# CITY OF HAM LAKE PLANNING COMMISSION AGENDA MONDAY, OCTOBER 23, 2023

**6:01 p.m**. Ryan Becker of Unlimited Concrete Concepts, LLC requesting a Conditional

- 1. Ryan Becker of Unlimited Concrete Concepts, LLC requesting Commercial Site Plan approval to construct a 4,608 square foot office/warehouse building at 16651 Polk Street NE. PID# 08-32-23-33-0007
- Jeff Stalberger, MN Development LLC, requesting Sketch Plan approval for a development located at 2506 Swedish Drive NE (47 Residential Single Family lots and 1 out lot) in Section 4

Unlimited Concrete Concepts, LLC requesting Site Plan Approval to build a 4,608 square foot office/warehouse building and a Conditional Use Permit to operate a construction service contractor business at

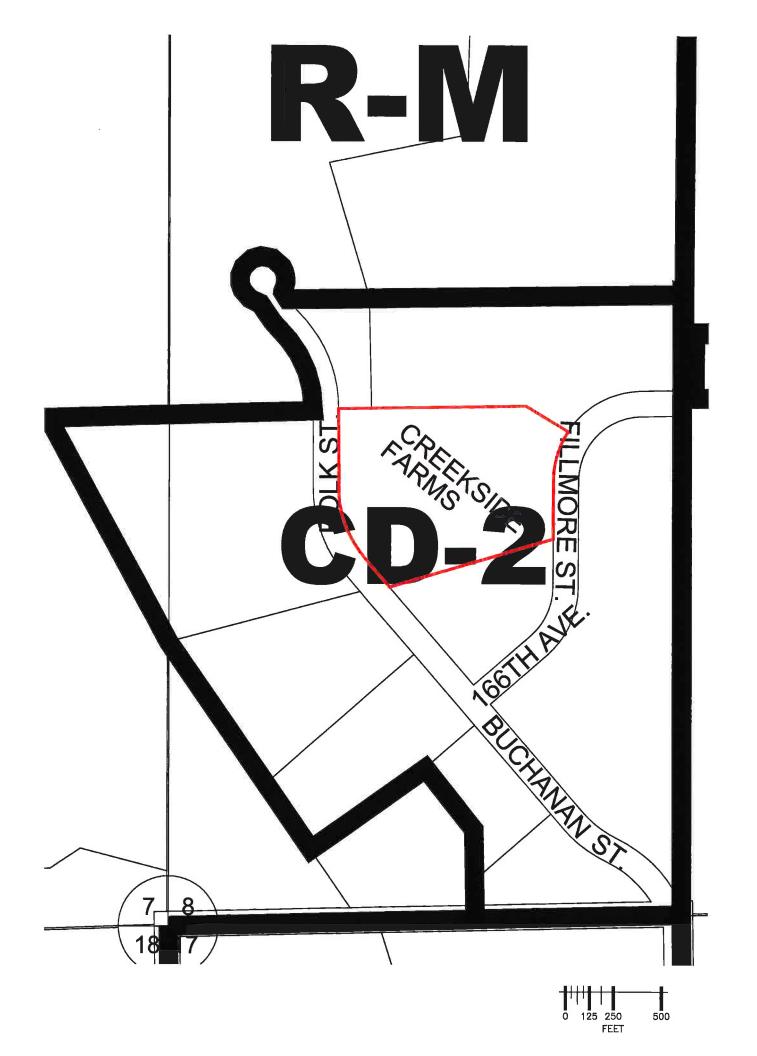
Per Article 9-220.1(2)(bb), Standards Common to All Mercantile Districts, Permitted Outside Storage, aesthetically screened outside storage is permitted outside storage if used as a condition of approval of any site plan, Conditional Use Permit or Temporary Conditional Use Permit on any CD-1 or CD-2 parcel in connection with the new construction of a main commercial building on the parcel. Aesthetically screened storage is storage defined as inventory... behind an opaque barrier constructed of masonry or brick, attached to and matching or complementary to the main building. The screening chosen should be a code compliant fence that is at least eight-feet high. The surfaces upon which motor vehicles will be parked or driven, and all areas in which pedestrians will be walking from point to point, shall be surfaced with asphalt or concrete, to specifications established by the City's Engineer per Article 11-1851. The surface inside of the screened area can be Class V.

I recommend approval of the site plan with the following conditions:

- All surfaces used for customer and employee parking and for storage of over the road vehicles shall be asphalt or concrete to specifications established and approved by the City Engineer.
- 2. All refuse containers are to be stored inside of the building. If refuse containers are stored outside, they must comply with Article 9-220.1.f.
- 3. Exterior finish of the building must meet CD-2 building standards.

I recommend approval of the Conditional Use Permit with the following conditions:

- 1. All outside storage is to be on a Class V surface screened by a code compliant fence that is at least eight-feet high.
- 2. Hours of operation are to be between 7:01 am and 10:00 pm

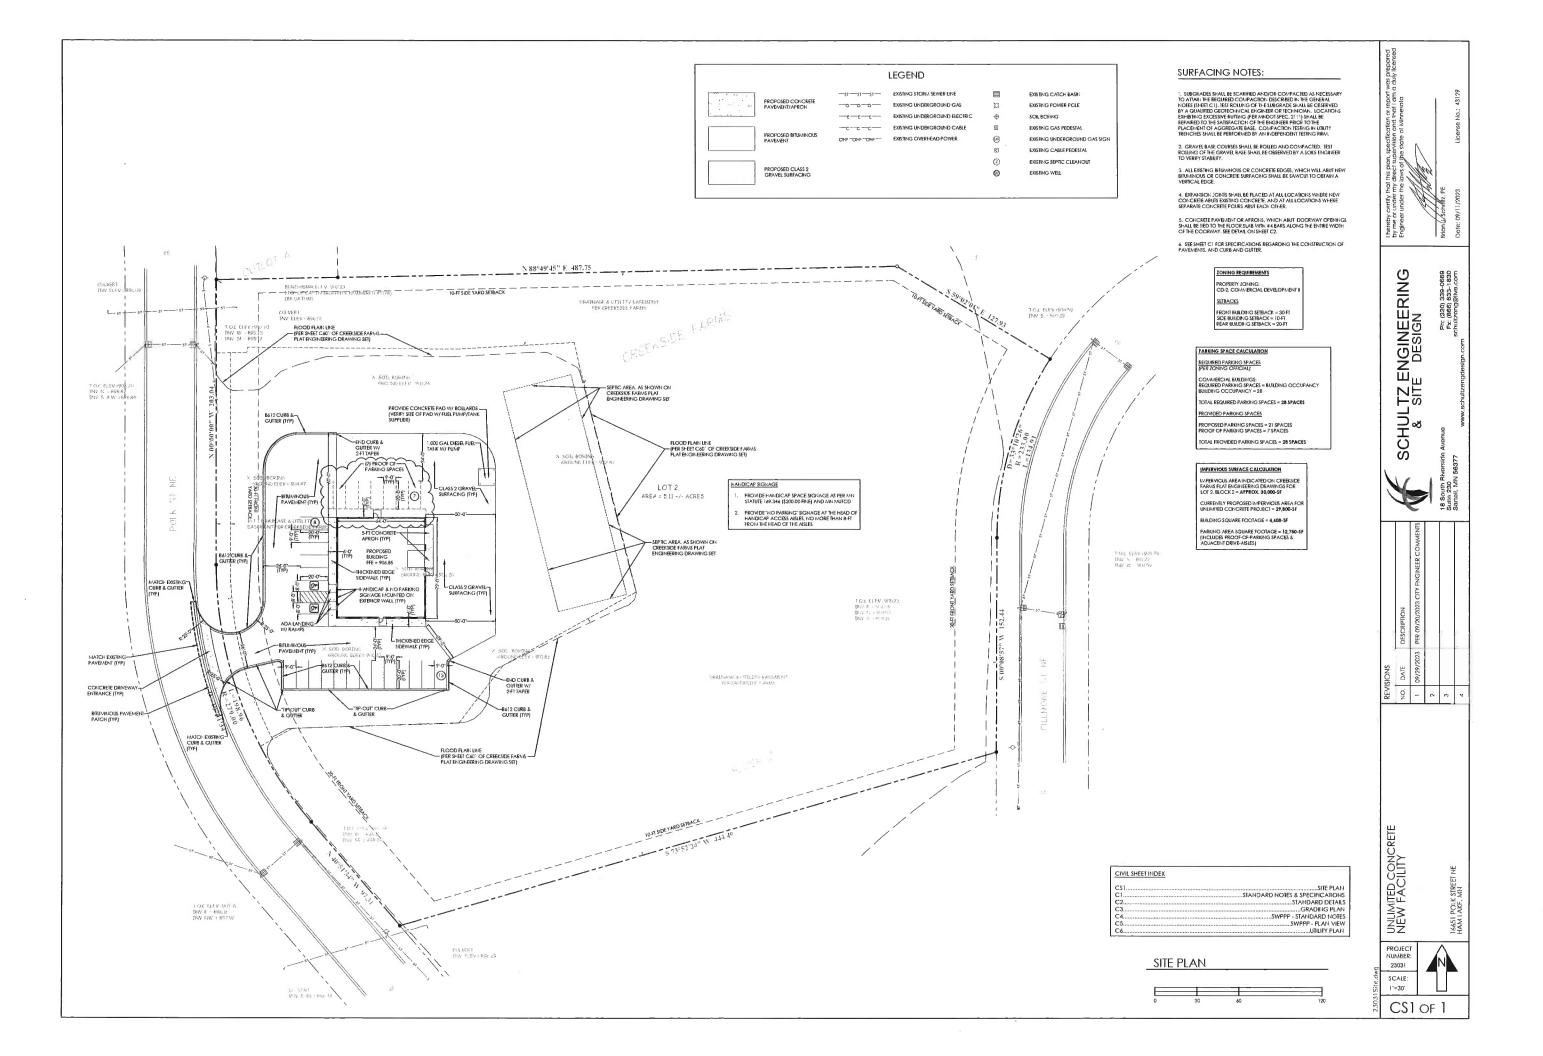
The Site Plan, Standard Notes & Specifications, Standard Details, Grading Plan, SWPPP – Standard Notes, SWPPP – Plan View, Utility Plan and Storm Sewer Design received October 2<sup>nd</sup>, the Exterior Photometrics received September 18<sup>th</sup> and the Architectural Plans received September 12<sup>th</sup> address prior review comments.

The attached Landscape Plan which was received on September 15<sup>th</sup>, shows trees surrounding the proposed building. Per 11-1853(B) of the City Code, decorative trees shall be planted along the right-of-way lines of adjacent public roadways. 11-1860 allows for case-by-case evaluation of landscape requirements for commercial land approval and "...strict adherence to the remaining provisions of Article 11-1800 may be unnecessary where size, spatial relationships, topography or other physical features render a given landscaping plan aesthetically acceptable, and departures from the strict observance of the elements of Article 11-1800 shall not be considered variances requiring a showing of physical hardship. Conversely, an applicant shall be expected to meet the general spirit of this article in establishing an aesthetically pleasing landscaping plan". A determination needs to be made as to whether the proposed landscaping is adequate adjacent to the public roadway or if additional screening should be required.

It is recommended that the Unlimited Concrete Concepts commercial site plan be recommended for approval, including the determination if the proposed screening is adequate.

Dosedel Parcel Sketch Plan

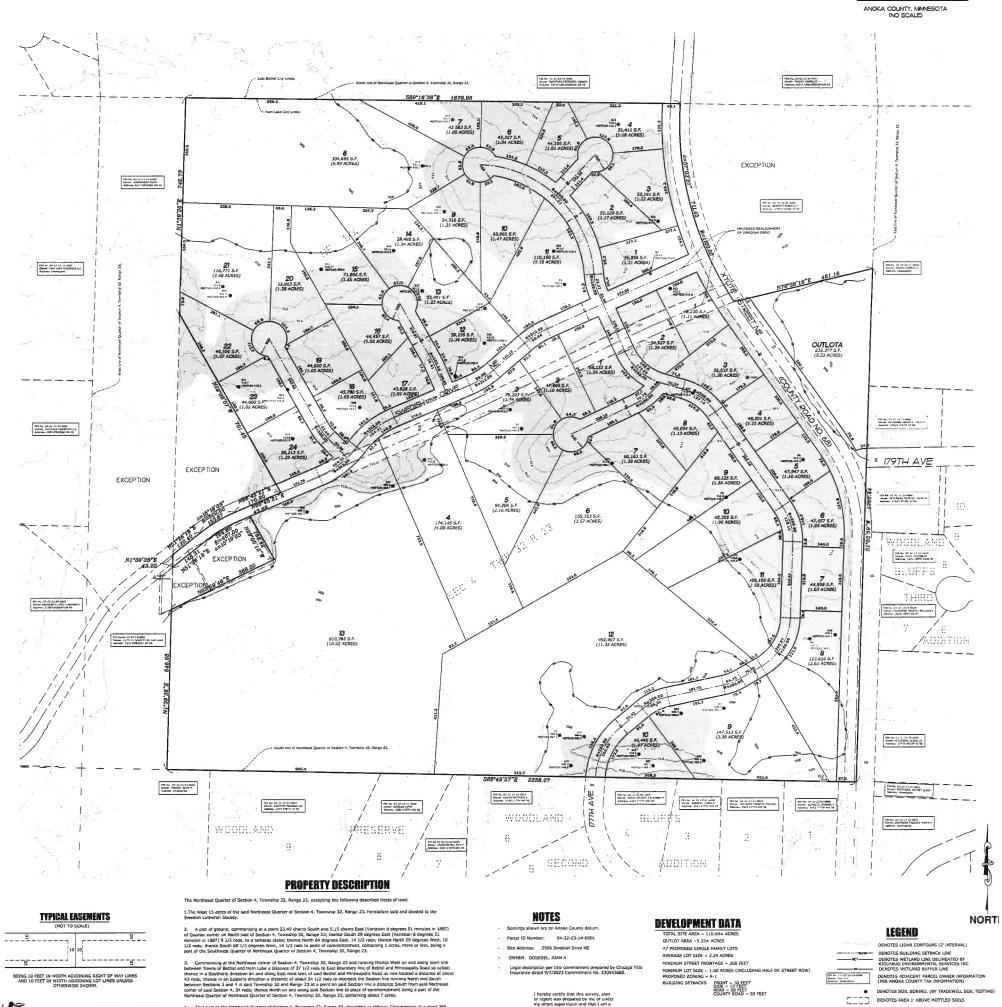
Swedish Drive was designated as an MSA route as part of the Crosstown Shopping Center project which is attached. The alignment of Swedish Drive is in general compliance with the thoroughfare plan, which has a future connection to 181<sup>st</sup> Street and Baltimore Street which is attached. The minimum design speed of Swedish Drive is 30 mph, which requires a minimum radius centerline of 312 feet. The centerline radii shown meets that requirement.

Xylite Street is under the jurisdiction of the Anoka County Highway Department. The attached Figure 32 of the ACHD 2040 Transportation Plan identifies CR 68 (Xylite Street) from Crosstown Boulevard to CSAH 22 (Viking Boulevard) as a major collector. Anoka County Highway Department (ACHD) comments are to be provided on the following:

The 04-32-23-13-0003 parcel is separate from the sketch plan and does not show right-of-way dedication for Swedish Drive. A separate document providing right-of-way from the owner will be required. The 04-32-23-13-0005 parcel shows an overlapping area with the Swedish right-of-way which will need documentation that there is no conflict or dedication from the owner for a 66-foot road right-of-way.

The Sketch Plan includes a 5.33-acre Outlot on the east side of Xylite Street. This reduces the land area of the 47 lots to 105.36 acres. The Outlot will need to be combined with an adjacent parcel 04-32-23-11-0001 (17943 Xylite Street), 03-32-23-22-0003 or 03-32-23-23-0002 (17833 Xylite Street). The Development Agreement will include conveyance of the Outlot to an adjacent property.

Swedish Drive is the jurisdictional boundary between the Coon Creek Watershed District (CCWD) and the Upper Rum River Watershed Management Organization (URRWMO). The parcels are within a drainage sensitive area, however since they will be regraded, this will be removed when the plat is completed. Parcels 4, 6, 12 and 13 are adjacent to County Ditch #58 which will require a 100-foot easement (50-foot either side of the centerline). The City of Ham Lake waived Wetland Conservation Act jurisdiction to CCWD for that portion of the project located outside of the CCWD boundary. That portion of the plans outside of the CCWD will be reviewed for compliance with the URRWMO Watershed Management Plan. A MnRAM will need to be submitted to ensure proper wetland setbacks are adhered to.

The Natural Resources Inventory and Assessment (NRIA) completed in 2008 by the Anoka Conservation District (Appendix S of the Storm Water Pollution Prevention Plan) does not identify any portion of the proposed development area as being within a Major Natural Resource Concentration per the attached Map 3. A Natural Heritage Information System data review by the DNR will be required to determine whether any state-protected species may be located within the plat boundary.

It is recommended that the Dosedel Parcel Sketch Plan be recommended for approval.
